This Amendment is issued to incorporate the following changes to solicitation SP0600-00-R-0048:

TABLE 1
 Fixed Inventory
 Wastewater Utility System Bolling AFB

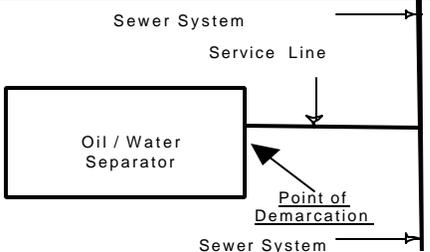
- H. Attachment J3 "Bolling AFB Wastewater System", para J3.2.1.2 Inventory, Table 1 replace with the following table:

Item	Size	Quantity	Unit	Approximate Year of Construction
ACP Pipe	6 inch	5,877	LF	1975
ACP Pipe	8 inch	38,370	LF	1975
ACP Pipe	10 inch	1,324	LF	1975
ACP Pipe	12 inch	3,843	LF	1975
ACP Pipe	15 inch	1,265	LF	1975
Cast Iron Pipe (slip lined)	4 inch	483	LF	1995
Cast Iron Pipe (slip lined)	8 inch	160	LF	1995
Cast Iron Pipe	6 inch	105	LF	1940
Cast Iron Pipe	8 inch	1,155	LF	1940
Cast Iron Pipe	10 inch	192	LF	1940
PVC Pipe	4 inch	13,001	LF	1975 – 1995
PVC Pipe	6 inch	70	LF	1975 – 1995
PVC Pipe	8 inch	6,145	LF	1975 – 1995
Vitrified Clay Pipe	6 inch	10,466	LF	1970
Vitrified Clay Pipe	8 inch	12,035	LF	1970
Vitrified Clay Pipe	12 inch	263	LF	1970
Vitrified Clay Pipe	15 inch	792	LF	1970
Vitrified Clay Pipe	16 inch	715	LF	1970
Steel Pipe	6 inch	74	LF	1940
Standard Sanitary Sewer Manhole, 12 ft deep	5 ft. I.D.	116	EA	1940 – 1995
Standard Sanitary Sewer Manhole, 12 ft deep	4 ft I. D.	233	EA	1940 – 1995
Wastewater Lift/Pump Station at building 6000	3315 gpm (total for all four pumps)	4 Pumps	One Station	1993

2 - 15 HP, 1500 gpm each, 1 – 5 HP, 350 gpm, and one 1/3 HP, 15 gpm sump pump

Wastewater Lift/Pump Station at the Marina	1490 gpm (total for three pumps)	3 pumps – 2 – 10 HP, 725 gpm each, - 1 1/3HP, 40 gpm sump pump	One Station	1997
Wastewater Lift/Pump Station at the Post Office	300 gpm	1 pump – 5 HP, 300 gpm, 4" discharge	One Station	1995
RPIE Emergency Generators for Sewage Equipment	None			
Wastewater Treatment Facility	None
